INTEROFFICE MEMORANDUM

TO: BRIDGE DESIGN PERSONNEL
FROM: Frank Harrison, Assistant Bridge Engineer
SUBJECT: Round Ties

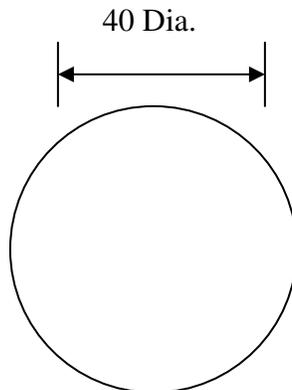
The bending diagram for round ties should be changed from that shown on our standard bending diagram sheet with end bends similar to a rectangular or square tie to a simple lap as shown below.
